SERVICE BULLETIN	
Product:	Microwave
Bulletin Number	ASC20150122001
Bulletin Date:	1/22/2016
Models:	ME179KFETSR/AA, MC17F808KDT/AA

SUBJECT: Engineering change to the main PCB and control panel.

ME179KEFTSR Control Design

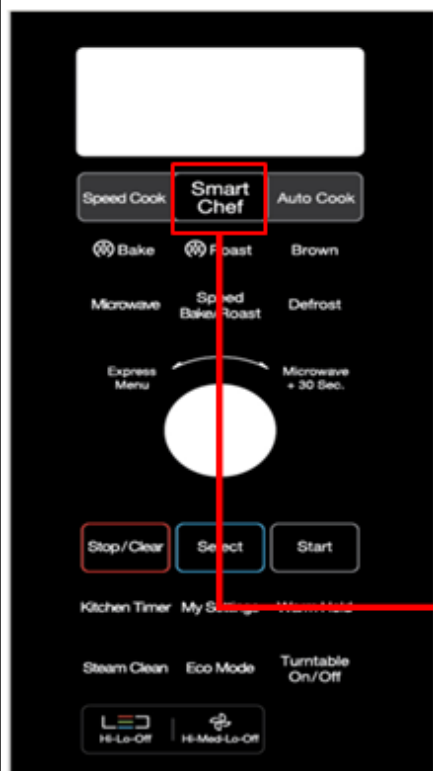
Please note that the Control Box Assembly (DE94-02944E) will be different than the original Control Box Assembly (DE94-02944A) on the ME179KFETSR/AA. The Smart Chef feature on the ME179 Control Box will be the Fit Choice Feature. In addition, the Slim Fry feature will be added. Please see the following graphic for more detail. A sheet will be provided with Control Box Assembly (DE94-02944E) to instruct the customer on how to use the Slim Fry feature.

"Slim Fry" function is added

ICON change
"Smart Chef" → "Fit Choice"

Solution: If the Control Box Assembly, Control Panel Assembly, or the Main PCB Assembly fails on the ME179KFETSR/AA or the MC17F808KDT/AA version 00 microwave, **replace the Control Box Assembly with Control Box Assembly DE94-02944E**. If the Control Box Assembly, Control Panel Assembly, or the Main PCB Assembly fails on a MC17F808KDT/AA version 01, replace the individual components with the parts listed under Service Part below (in light blue).
